**Marion County
Board of County Commissioners**

**PLANNING & ZONING SECTION
STAFF REPORT**

P&ZC Date: 10/30/2023	BCC Date: TBD
Case Number:	231111ZP	
CDP-AR:	30579	
Type of Case:	Rezoning from General Agriculture (A-1), Agricultural Estate (A-3), Community Business (B-2) and Light Industrial (M-1) to Planned Unit Development (PUD)	
Owner	Multiple Owners, c/o Robert A. Bull Agent, Tillman & Associates Engineering, LLC	
Applicant	Tillman and Associates Engineering, LLC	
Street Address	Address not assigned; Jumbolair	
Parcel Number	14106-000-00, 14591-000-00, 14105-000-00, 14601-001-00, 14202-000-00, 14600-001-00, 14560-000-00, 14567-001-00, 14567-000-00, 14571-000-00, 14561-000-00, 14569-001-00, 14569-000-00, 14574-000-00, 14568-000-00, 14575-000-00, 14592-006-00, 14601-000-00, 14605-000-00, 14583-002-00, 14583-001-00, 14583-003-00, 14730-000-00	
Property Size	±449.66	
Future Land Use	Rural Land (RL), Low Residential (LR), Medium Residential (MR), Commercial (COM)	
Zoning Classification	General Agriculture (A-1), Agricultural Estate (A-3), Community Business (B-2) and Light Industrial (M-1)

**Figure 2
Conceptual Plan**

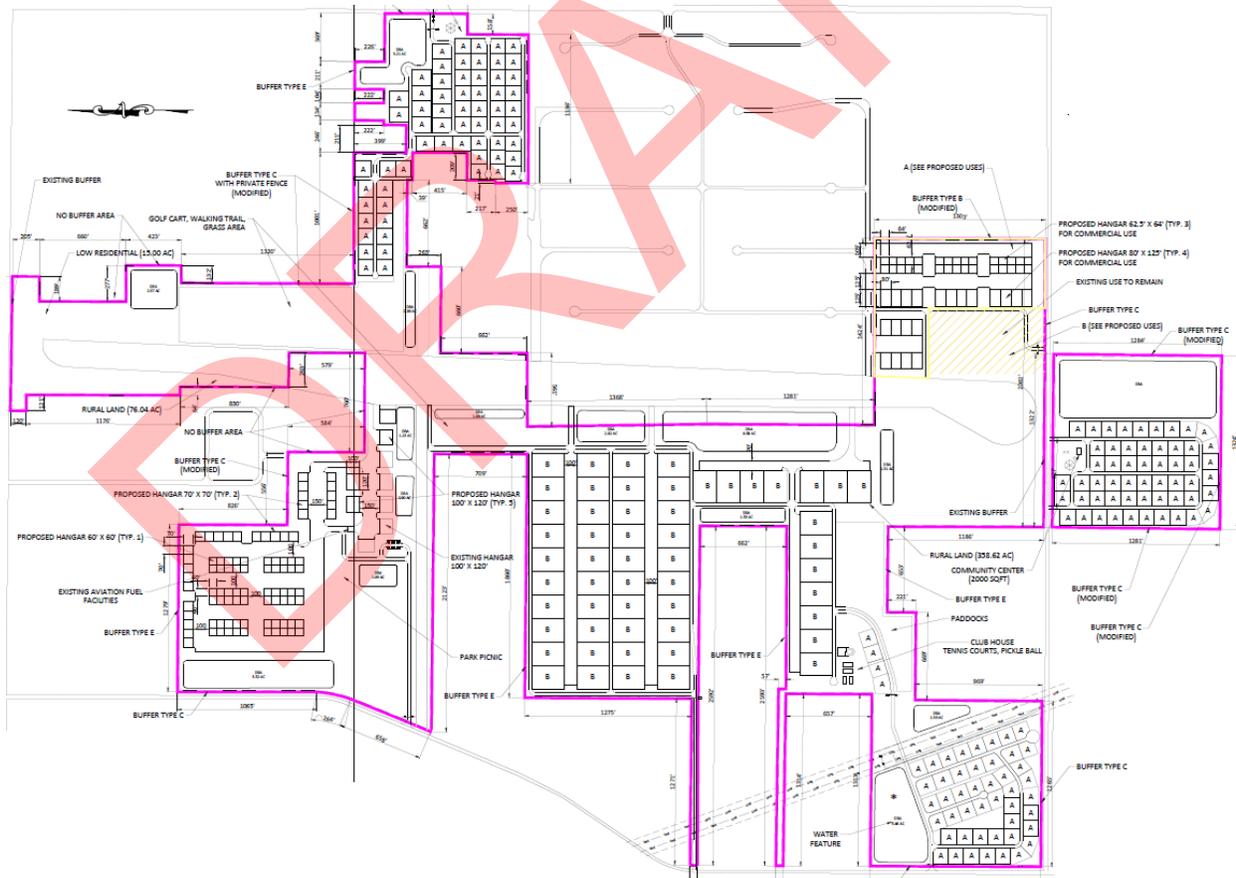
The PUD also proposes multiple areas for hangars; 90 hangars are proposed in the Farmland Preservation area, and 50 hangars are proposed in the commercial area adjacent to the 11.02 acres of M-1. The hangars adjacent to the M-1 zoning are intended for commercial uses, while the hangars in the Farmland Preservation Area are proposed for the private use of residents within the community. Looking at the other fly-in communities within the county, including Jumbolair, those communities have hangars on the same property as the primary home. Staff is adding a condition to make this PUD consistent with those existing communities.

The Notes section of the PUD Conceptual Plan, includes permissions that allow: (1) the Commercial land use area a 1.0 Floor Area Ratio (FAR) (This is 1.3 million GSF of commercial use area), (2) buffers approved by the Board may be waived by DRC with consideration of existing vegetation and/or letter from adjacent property owner, and (3) that the applicants reserve the ability to rearrange or modify location of housing unit types prior to approval of final master plan, and further, (4) that provisions for adequate buffers will be provided. Conditions are proposed by staff to address these issues.

- The PUD is restricted to a total of 240 residential units and accompanying accessory amenities consistent with the Marion County Land Development Code, the PUD Application, and PUD Concept Plan (Dated 01/05/2024; attached).
- The PUD shall be restricted to one-story homes along the boundaries of the project.

- Commercial uses are limited to those uses that are only listed in the B-4 zoning classification, including warehouse offices for the specific uses listed on the Conceptual plan, and completely enclosed within the hangars. Staff does not support expansion of the commercial area on the site, this condition is only here if the BOCC approves commercial land use expansion.

- Hangars for accessory use shall only be on the property with a primary home.
 - Hangars for commercial use are limited to the commercial area.
 - No commercial uses may be permitted within the Farmland Preservation Area.

- Buffers approved with this PUD shall not be waived by DRC.
 - Any housing units rearranged or have the locations modified shall be shown on the Master Plan for final approval and be buffered with buffers that meet the standards of the LDC without the ability for waivers or modifications.

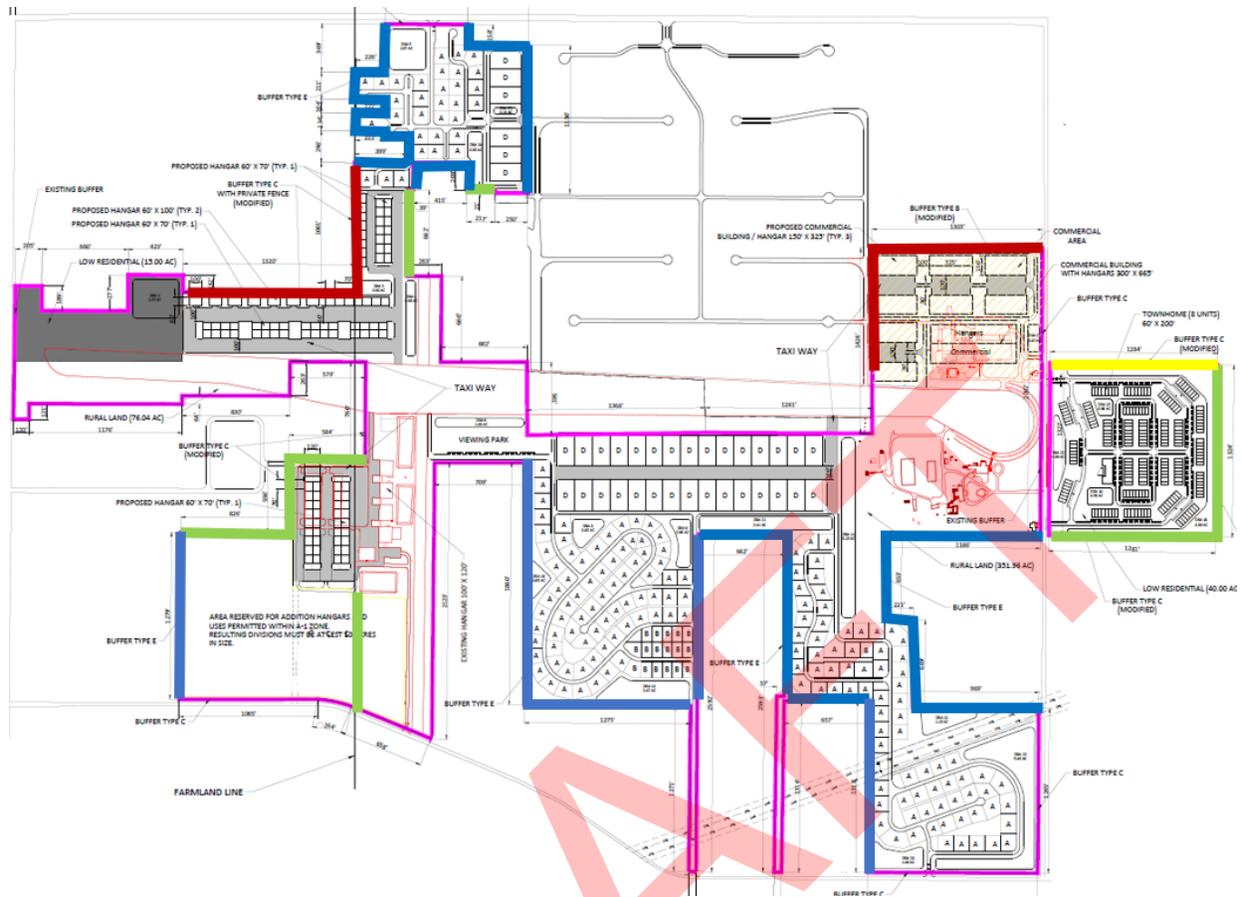
Analysis: Buffer details are proposed within the application (see Attachment A). Staff finds that the PUD is proposing a series of modified buffers that are less than the standards required in the Marion County Land Development Code. Other areas are proposing no buffers. The surrounding residential uses have much larger lots than the lot sizes proposed in the PUD. To help with compatibility, staff recommends the following conditions be imposed:

- Buffers shall be provided as shown on the submitted conceptual plan, and as noted below.
 - Lime Green line: Leave existing trees in place and install a 6' opaque vinyl fence on the interior side of the line.

- Dark Blue line: Modified Type E buffer with a 6' opaque vinyl fence on the interior of the buffer and shall consist of a five-foot wide landscape strip without a buffer wall. The buffer shall contain at least four shade trees for every 100 lineal feet or fractional part thereof. Shrubs shall be planted in a double-staggered row and be capable of reaching a maintained height of six feet within three years. Groundcovers and/or turfgrass shall not be used in this buffer.

- Yellow line: Modified Type C Buffer that is 10' wide as shown in the application but with a 6' opaque vinyl fence.
 - Dark Red line: Modified Type B buffer as shown on the conceptual plan. The opaque fence shall be vinyl and on the interior of the buffer.

- A Type C Buffer shall be included along all right-of-ways.
 - Any buffer not addressed with these conditions shall meet the standards of the Marion County Land Development Code.
